# SERVICE BULLETIN

SERVICE BULLETIN NO: 32-015

**LANDING GEAR - MAIN LANDING GEAR  
INSPECTION OF THE LANDING GEAR ASSEMBLIES AND REPLACEMENT OF THE SHOCK  
ABSORBER ATTACHMENT BOLTS**

MLG - Replacement of Components  
Figure 1

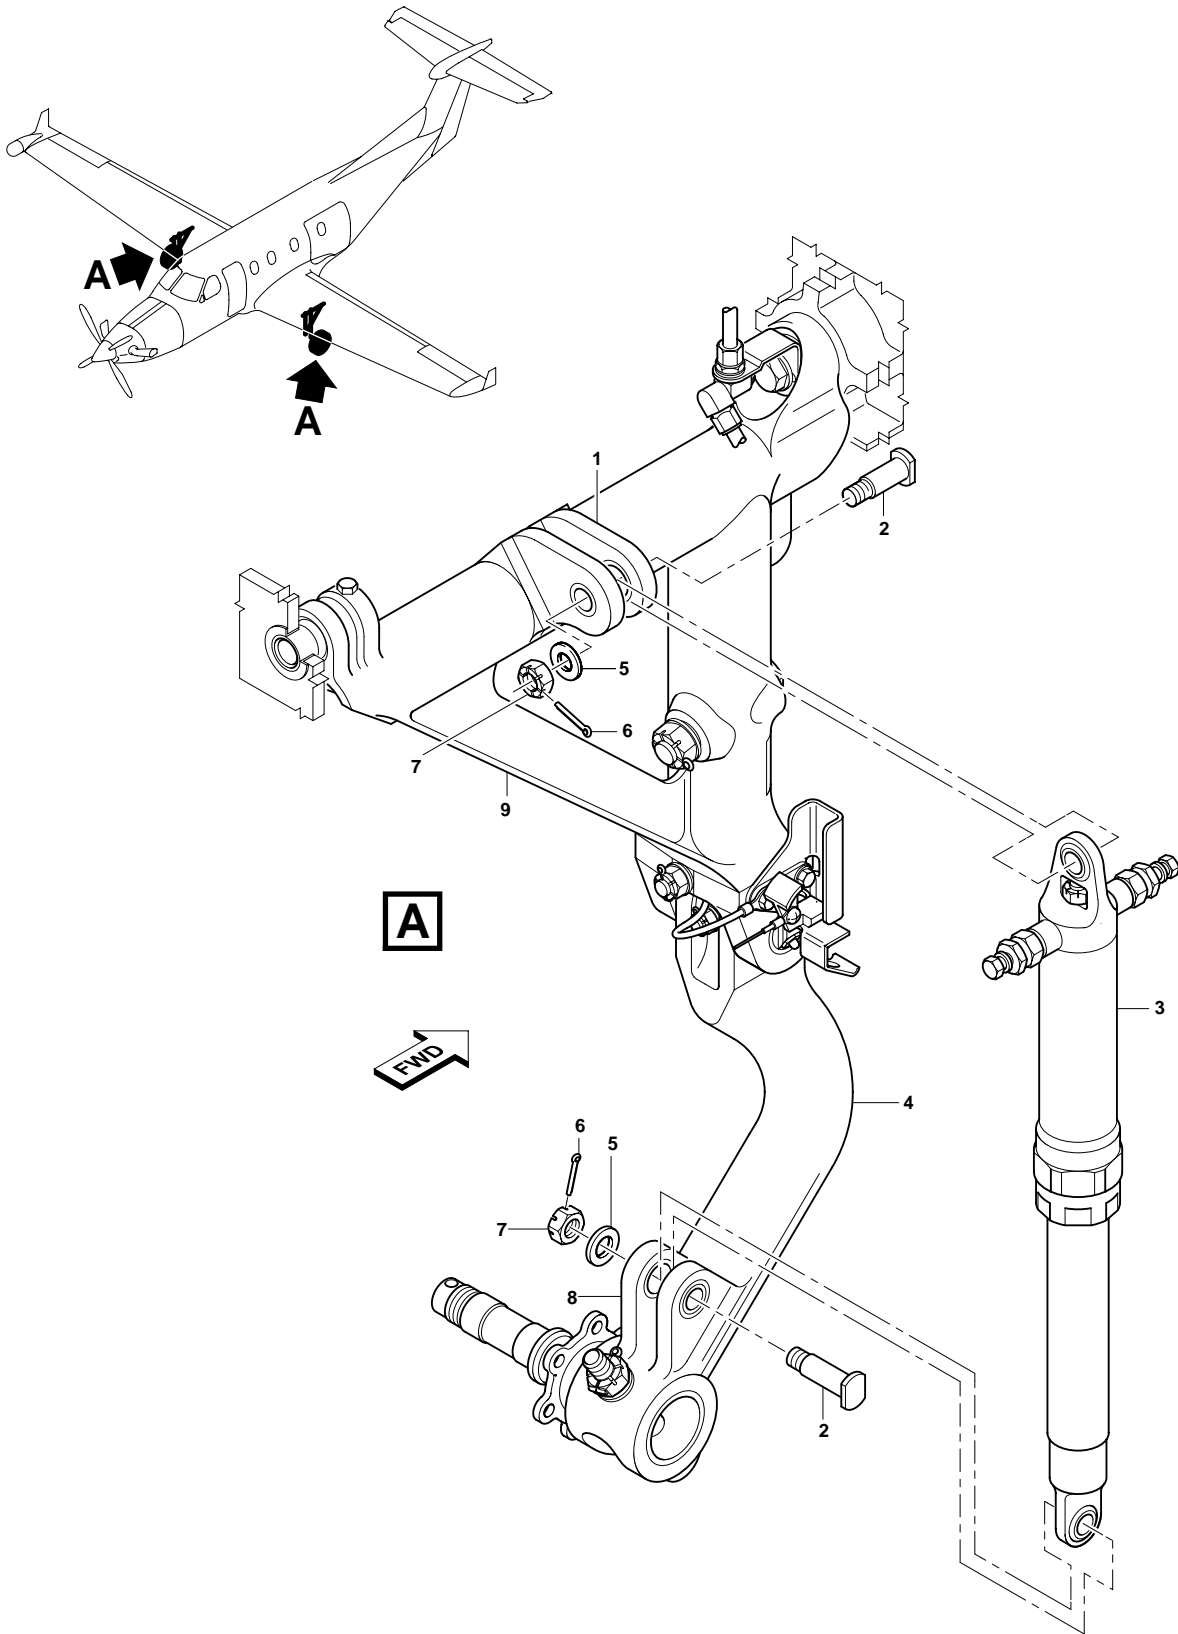
It is possible for the shock-absorber attachment bolts (special bolts) in some MLG assemblies to be defective. The problem is only applicable to MLG assemblies with serial numbers that start with the letters AM.

It is now known that it is possible for hydrogen embrittlement to occur during the manufacture of the special bolts.

Replace the special bolts (2, Fig 1) in all assemblies with serial numbers that start with the letters AM (Ref. Part B). It is not necessary to replace the special bolts in assemblies with serial numbers that do not start with the letters AM.

- (1) Remove the shock absorber.
  - (a) Remove the cotter pins (6), nuts (7) washers (5) and special bolts (2). Discard the cotter pins.
  - (b) Remove the shock absorber (3) from the trunnions (8) on the trailing link (4) and the trunnions (1) on the yoke fitting (9).
- (2) Send the special bolts (2) to PILATUS.
- (3) Install the shock absorber.
  - (a) Put the shock absorber (3) in position between the trunnions (1) and (8).
  - (b) Put the new special bolts (2) in position and install the washers (5), nuts (7) and cotter pins (6) (Ref. AMM, 20-20-00, Page Block 1).
